**General Service Bulletin No. 1**

Subject: Trailing Edge wing drainage

**Service Bulletin: 10,000-1**

**Service Bulletin: 10,000-2**

Subject: Wing Fabric Pull Reinforcements

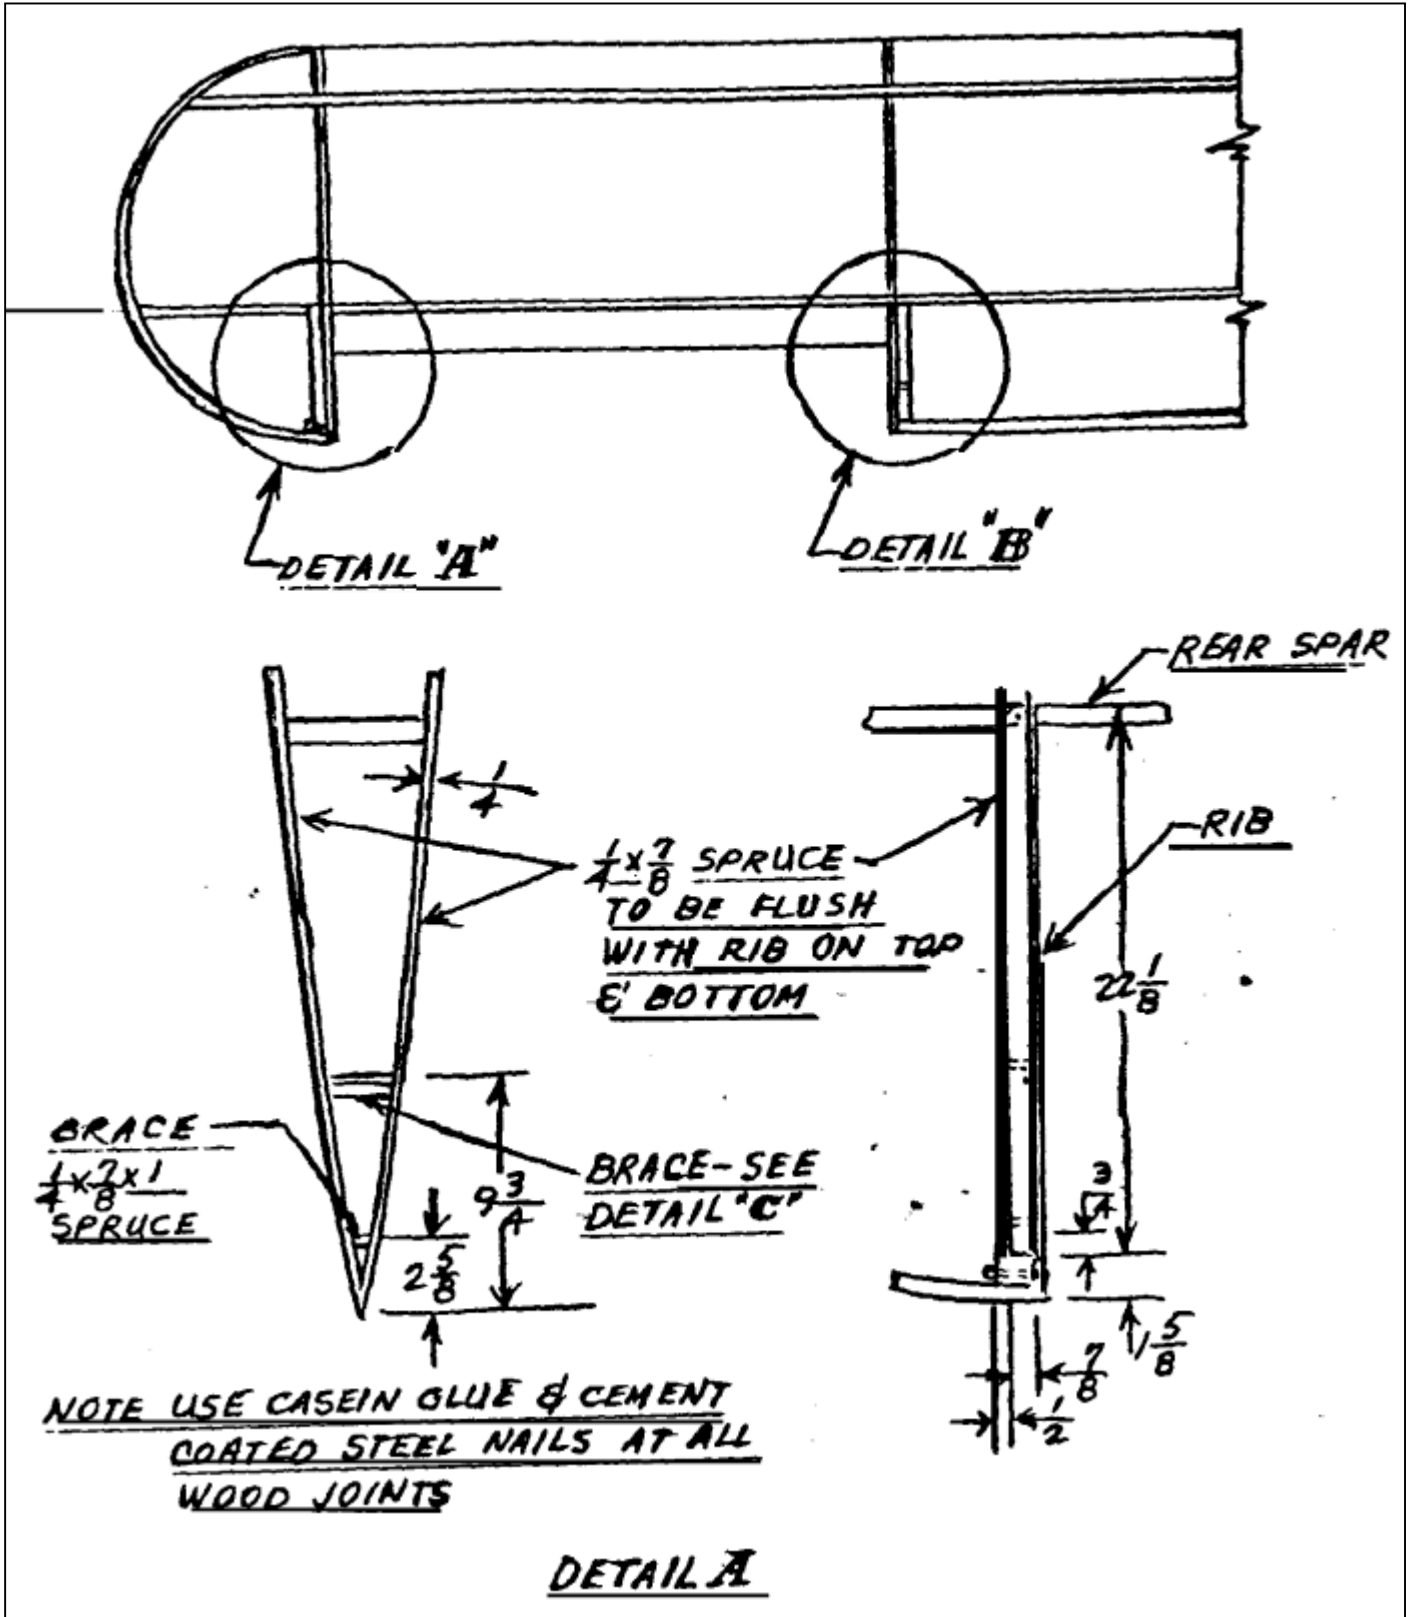
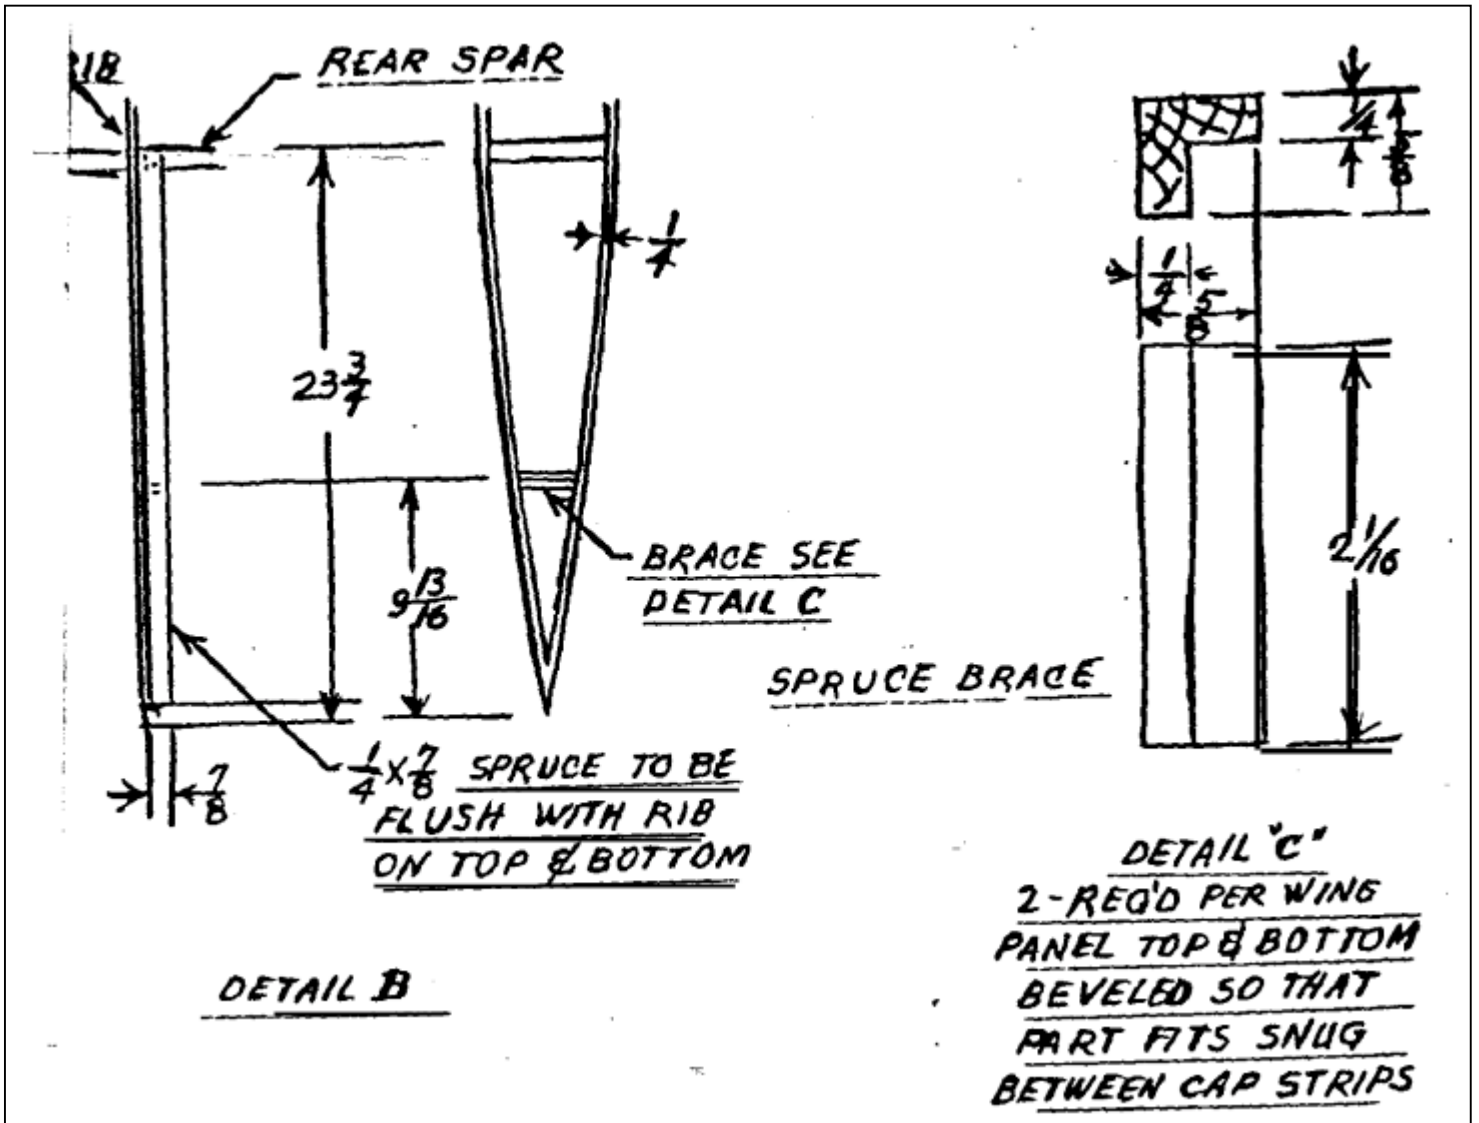
Present production calls for reinforcing strips extending along the inboard side of the top and bottom cap strip on wing rib at the inboard end of the aileron cut out. These strips run from the front face of the rear spar to the wing trailing edge and serve to restrain the rib laterally against fabric pull. On some of the earlier airplanes (see serial numbers applicable) the reinforcement strip stopped at the trailing edge of the wing in the aileron section. This resulted in a few cases of the wing rib rupturing just aft of the aileron cut out trailing edge. It is recommended that these strips be added to your airplane to prevent this from occurring. See attached sketch relative to detail of the pertinent strips and their attachment.

It is also desirable to add fabric pull strips to the rib at the outboard section of the aileron cut out section similar to those at the inboard section described in 2nd paragraph above. In this case, it is necessary to add a solids block at the trailing edge of the wing which hooks around the fabric pull strips to restrain them at the trailing edge against the lateral pull of the fabric. This block is bolted in place. For the details of this change refer to the attached sketch. It is recommended that your airplane be altered to comply with this suggestion at an early date.

Subject: Fabric pull on wing trailing edge.

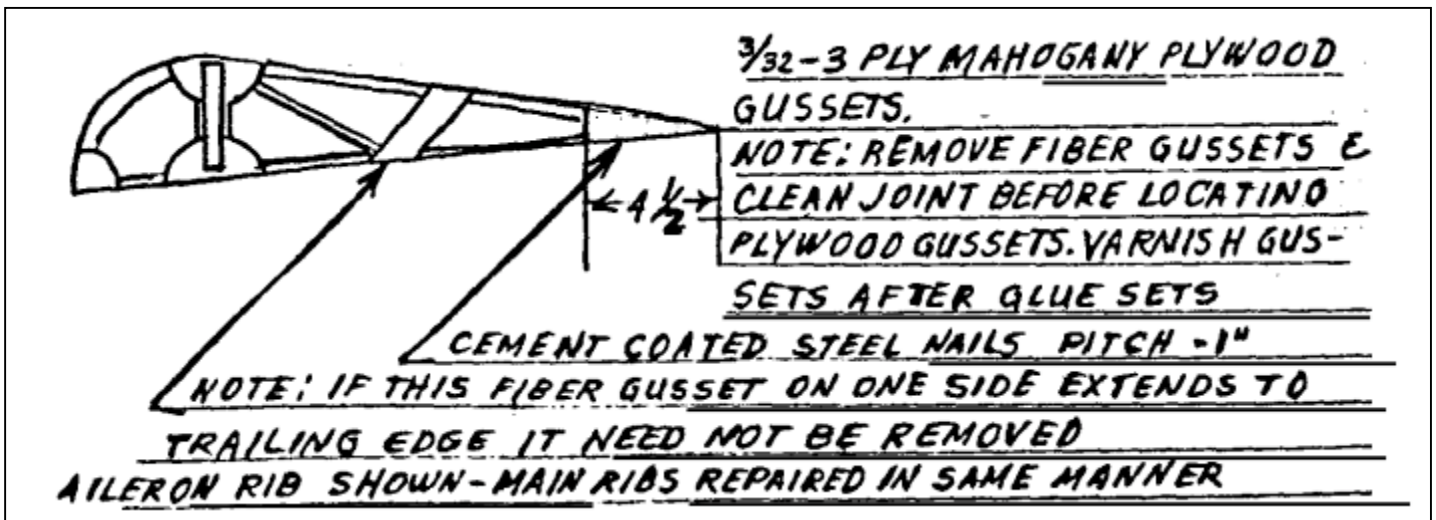
In certain cases the wing trailing edge has been rotated due to fabric pull. In most cases reported, the trailing edge turned upward in the region between the aileron and the fuselage, and it is recommended that the following repairs be executed in your ship to preclude this difficulty, It would probably be well to effect this change on the ailerons, as well as at the trailing edge portion of the wing as a precautionary measure.

It is recommended that 3/32 mahogany 3-ply plywood, resin bonded, gussets be located on either side of the wing rib as outlined in the sketch below, Casein glue should be used and should be mixed and applied in accordance with approved practice. The plywood gussets should be retained by nailing as indicated in the sketch below. In the event that the rib cap strips are injured by the fabric pull, they should be repaired in accordance with approved methods outlined in C.A.R. 18 and A.C.M. 18 issued by the C.A.A.

Subject: Trailing edge wing drainage

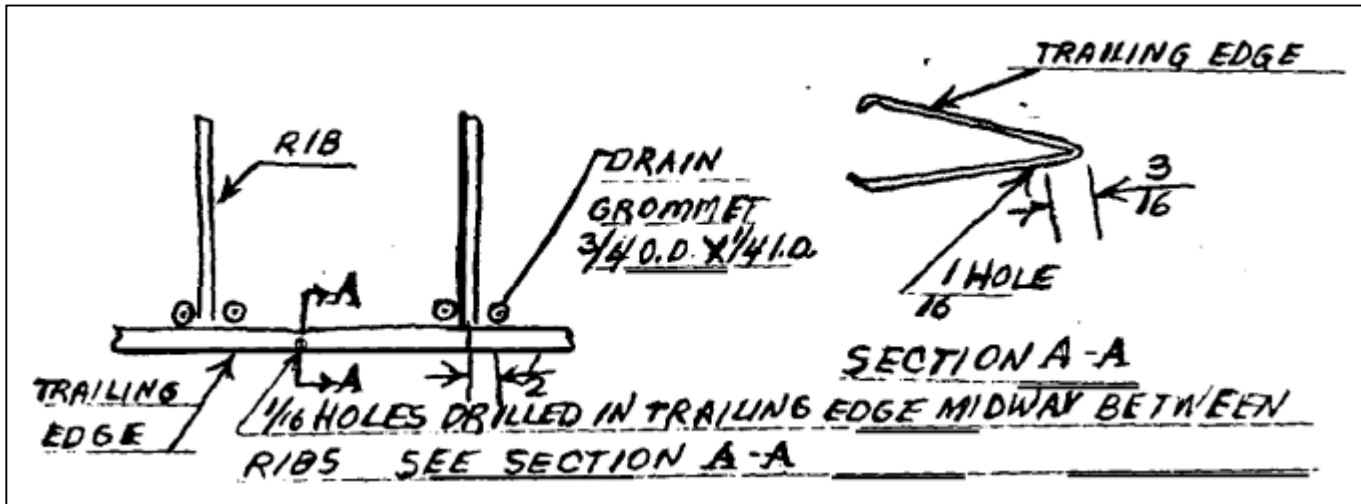
2. Additional drain holes and grommets should be located in the trailing edge portion of the wing and aileron on all of the subject model airplanes. This includes the trailing edge portion of the wing in the aileron cut out region. In addition to this, 1/16" holes should be drilled through the lower surface of the trailing edge approx. 3/16" from the rear edge of the trailing edge strip between all ribs. Note sketch below.

Subject: Drainage-landing gear vees

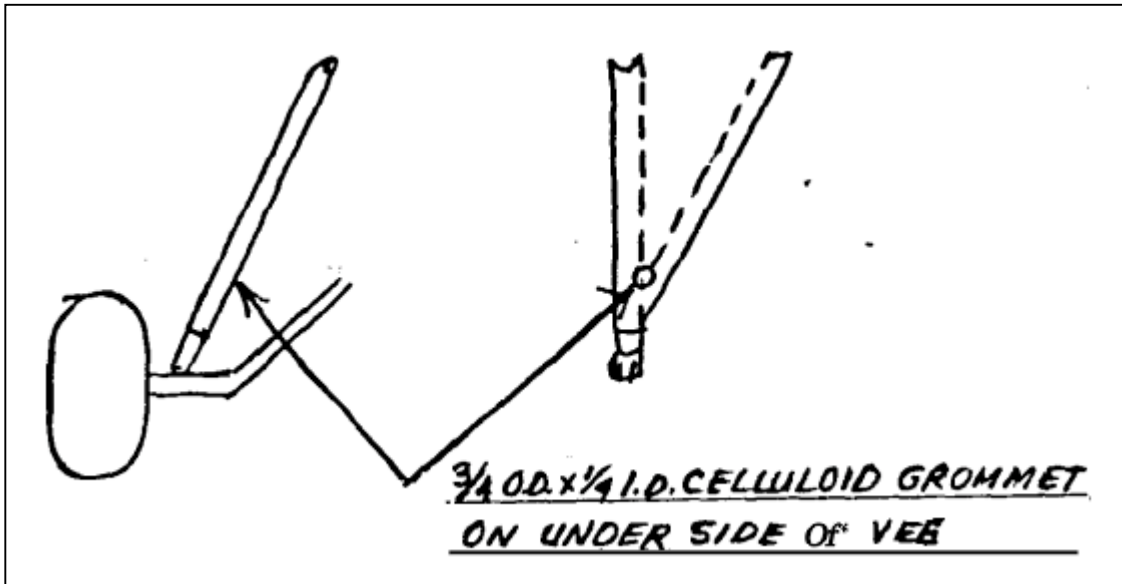
It may be possible for the landing gear vees to retain water between the structural members and the fabric covering at the apex of the vee. In order to remove this possibility, it is recommended that a drain grommet be placed at the apex of the vee on the fabric on the side of the vee nearest the center line of the airplane. This grommet should be applied to both the right hand and left hand vees.

The following sketch illustrates the proper location for the grommets.

Subject: Inspection of spars at the fuselage attachment fittings

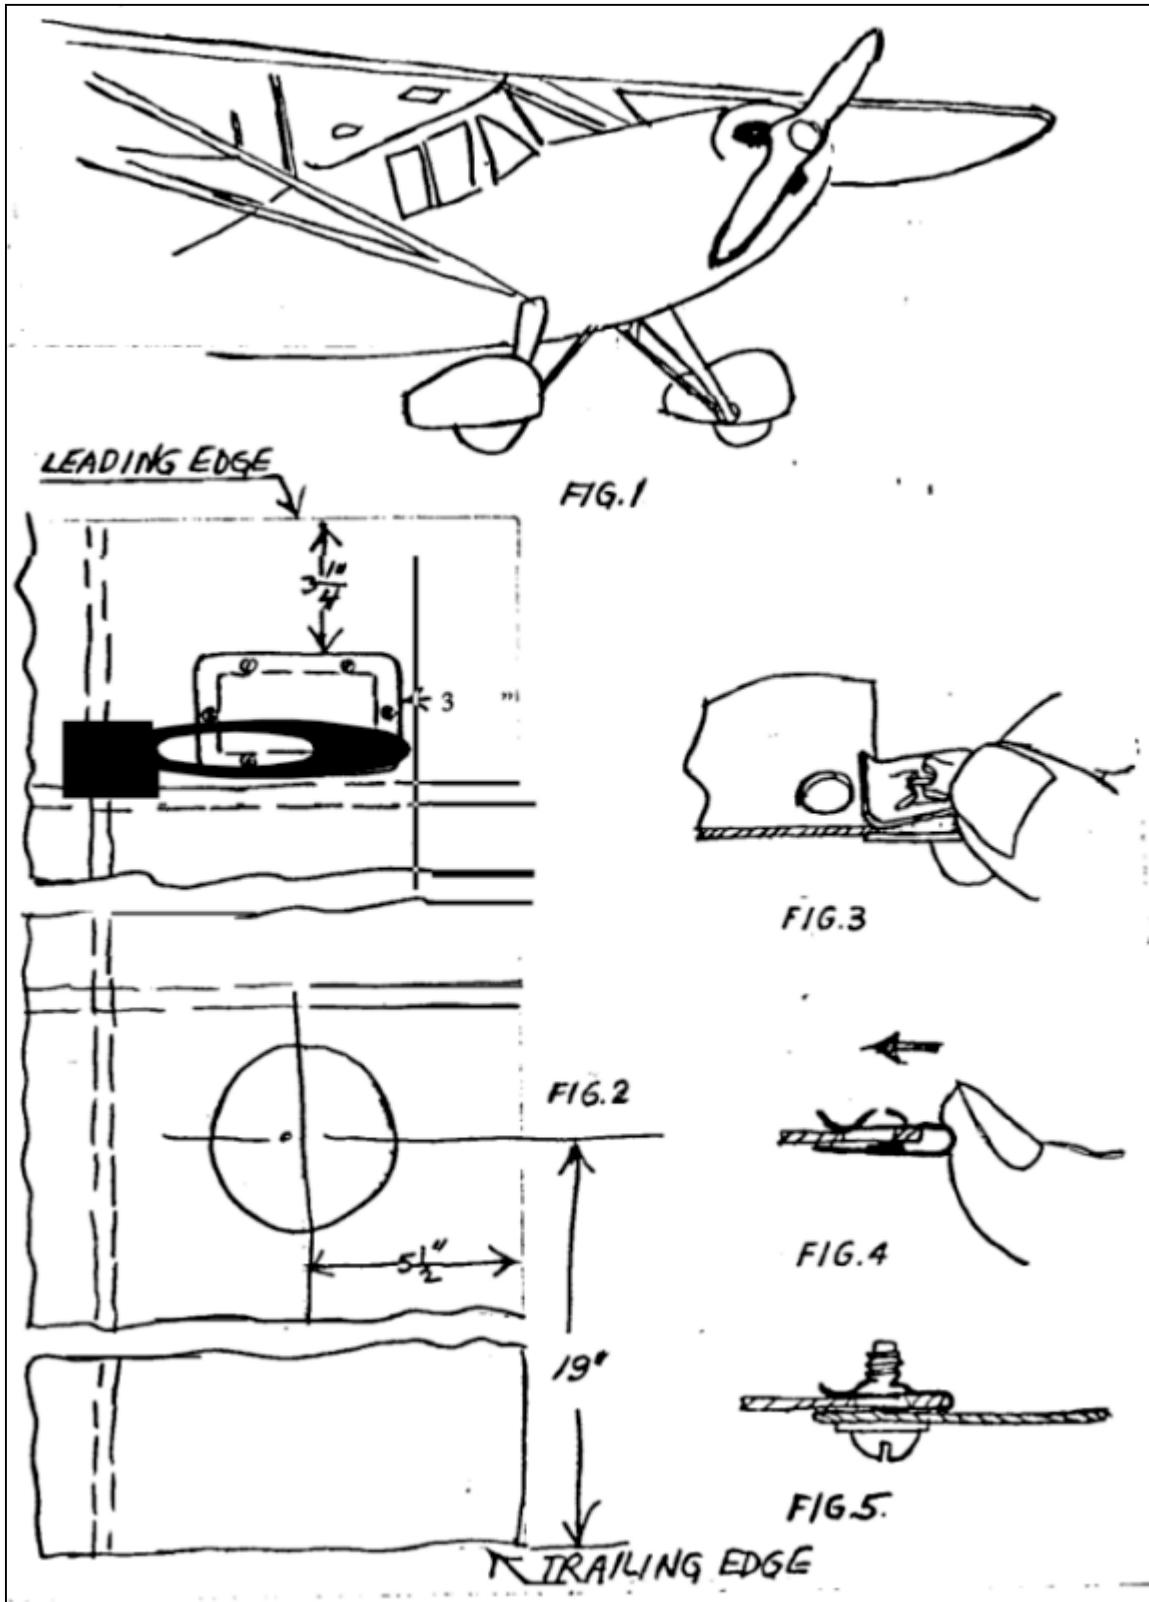
The inspection plate for the front spar should be installed in the leading edge skin immediately in front of the spar as shown in Fig. 1 & 2. In doing this, the following steps should be followed:

- a) Place the cover plate in position approx. as shown in Fig, 2 and use a template in marking location of holes.
- b) Use holes thus marked to lay out opening to be cut in skin, which should be 2" x 4" and centrally located within the area of the holes marked.
- c) Drill 6-1/4" holes in the position previously marked. Care should be taken in drilling holes to avoid tearing of the thin aluminum skin.
- d) Place speed nut clips over edge of skin and push into holes as shown in Figures 3 & 4.
- e) Place cover plate over opening and insert screws. Work should be done with precision in order to get proper alignment of holes with speed nuts.

The inspection plate for the rear spar should be installed immediately behind the rear spar in the fabric as shown in Fig. 1 & 2. The inspection spate assembly consists of pyraline ring doped to the fabric surface with either clear or pigmented dope. After the ring has dried to the surface, an additional coat of dope should be applied to the exterior of the ring. After drying, the fabric is cut from the ring I.D. and the aluminum plate (retained by a spring clip) is inserted.
